Appl. No. 10/642,313
Reply to Office action of December 17, 2004

Remarks

ANNOTATED MARKED-UP DRAWINGS

**FIG. 5****FIG. 6**

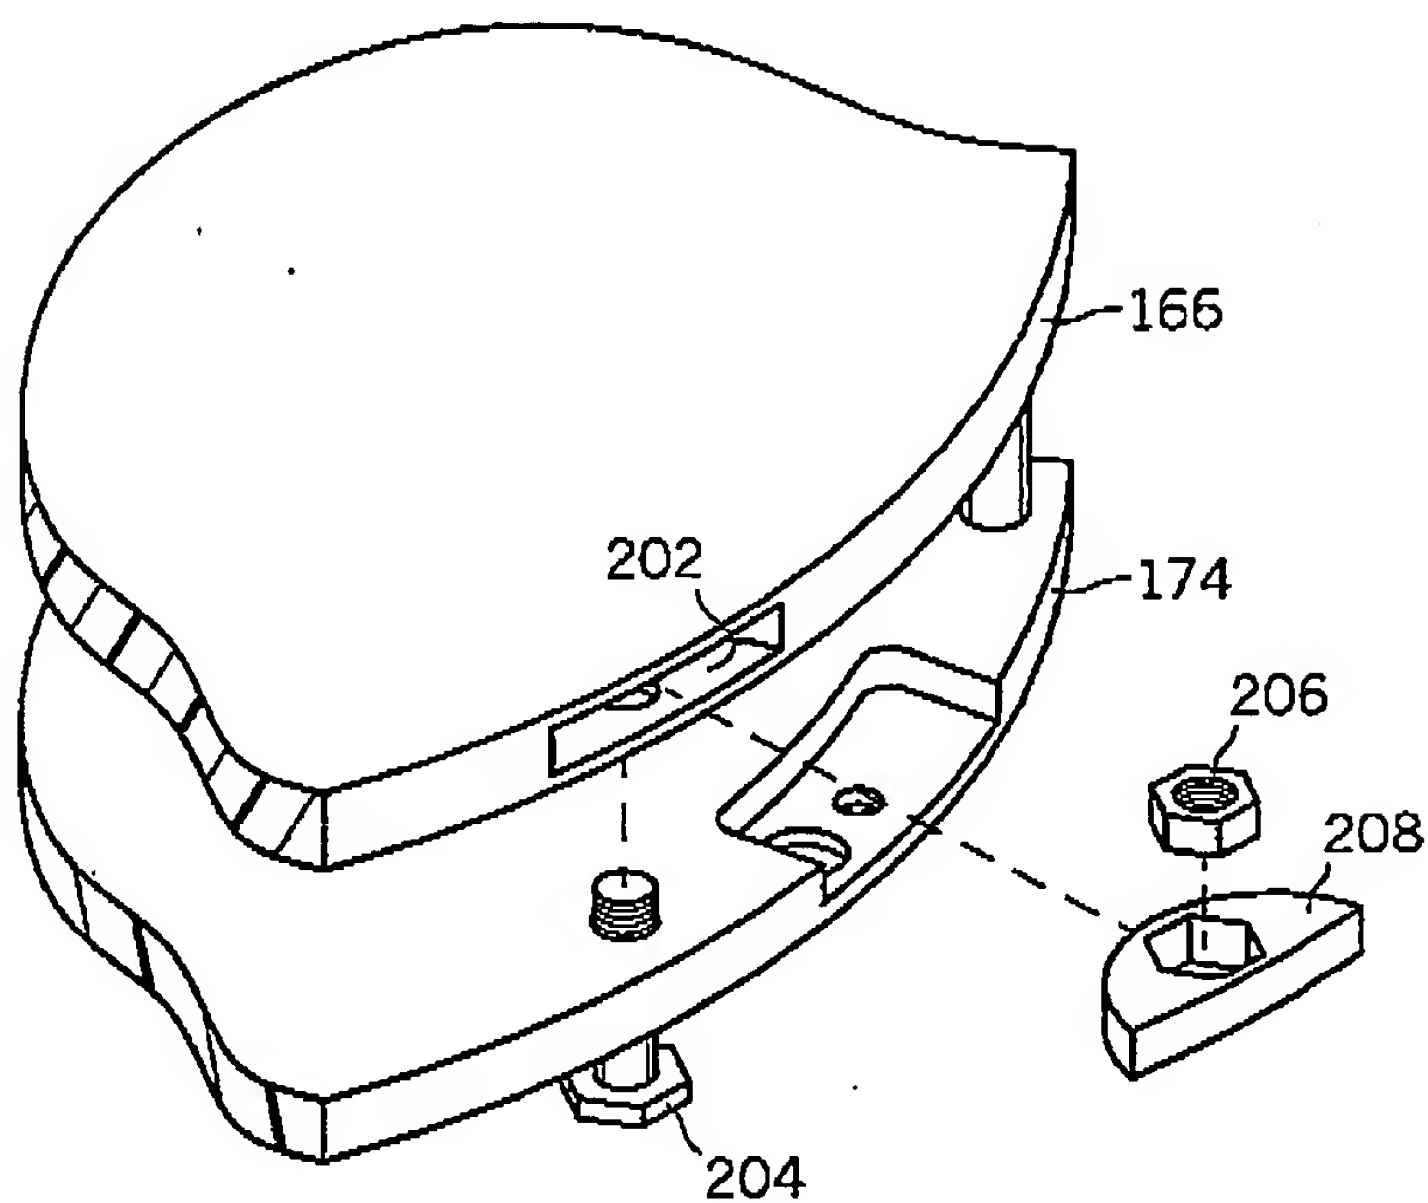
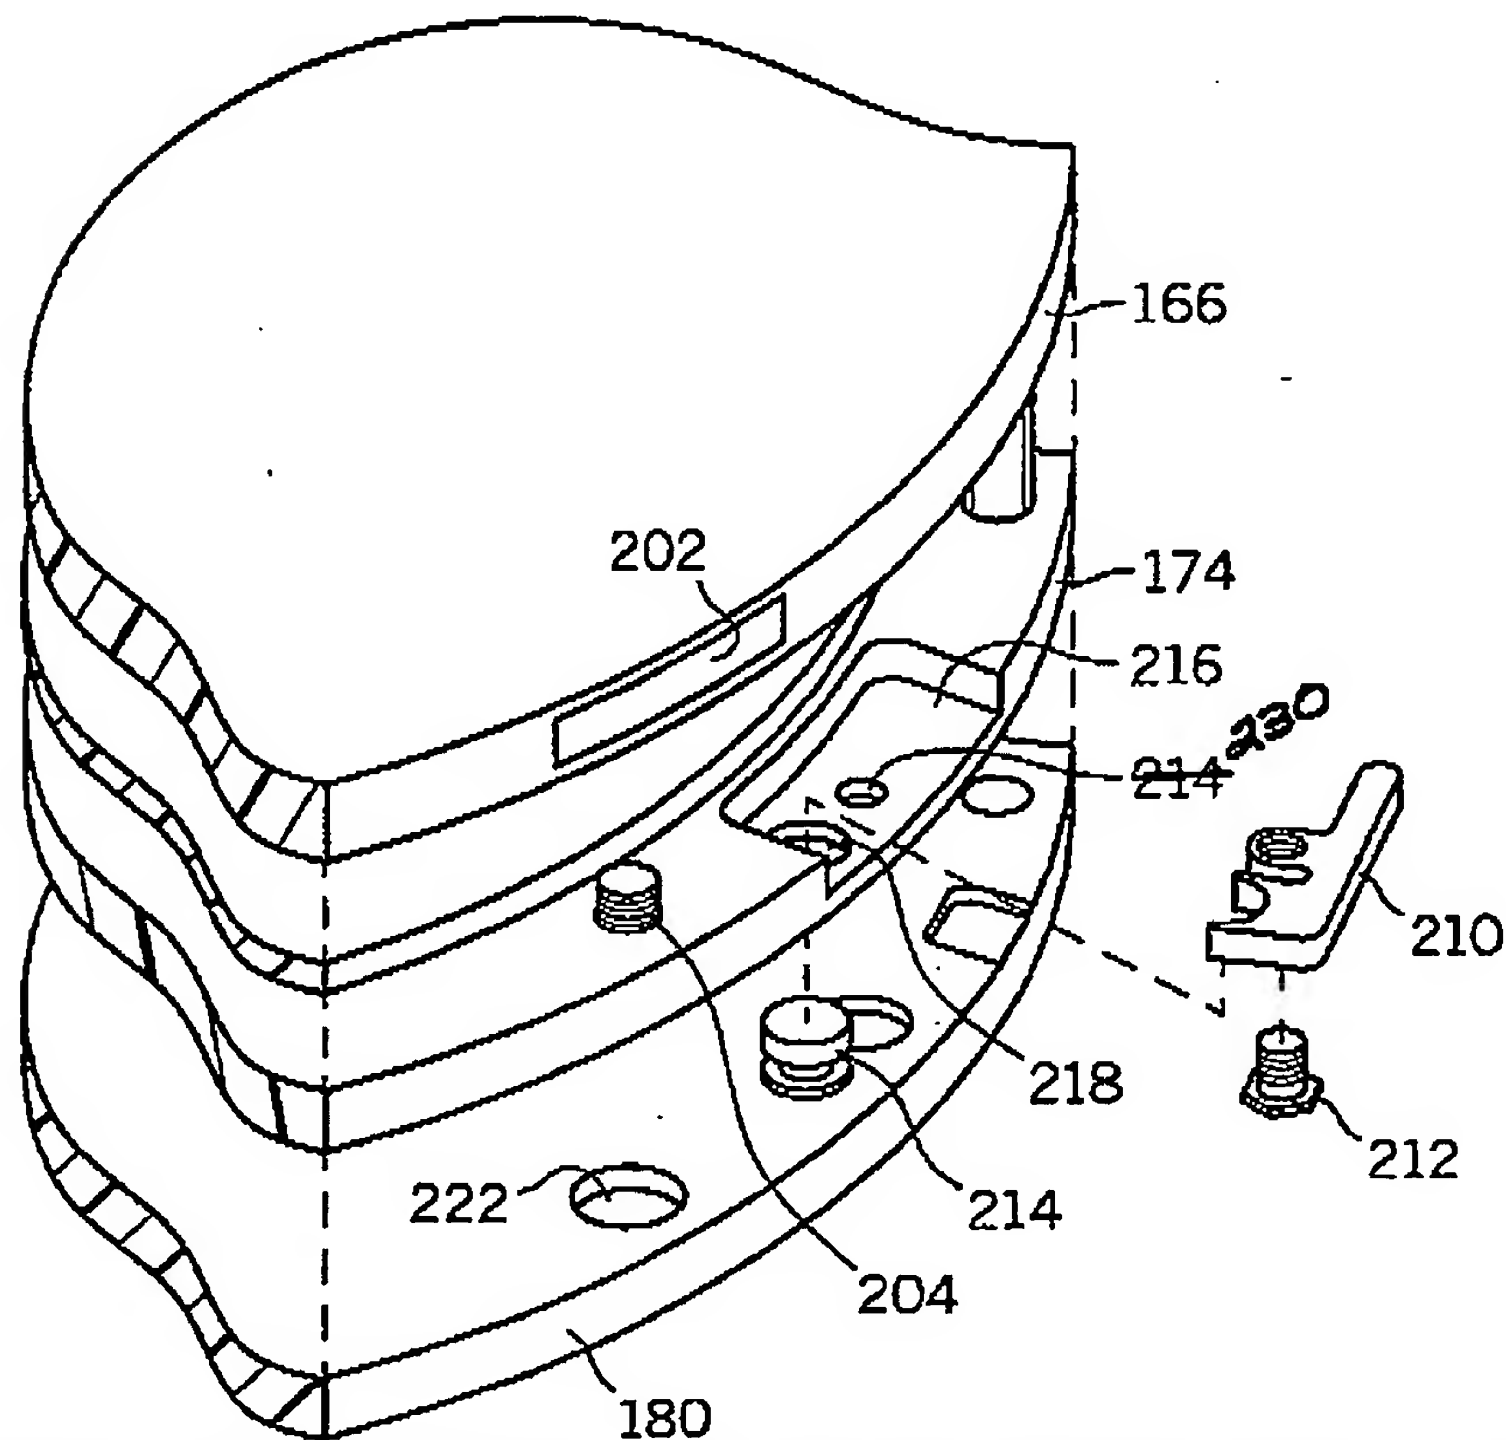
The drawings were objected to for using the same reference numeral to refer to two different elements. FIG. 8 has been amended to assign the number 230 to one of those elements. In reviewing the application, Applicants' attorney noticed that FIG. 6 suffered from the same type of error. Accordingly, FIG. 6 has been amended to apply the reference number 197 to the hollow portion of the light pin. FIG. 2 has also been amended to assign the reference
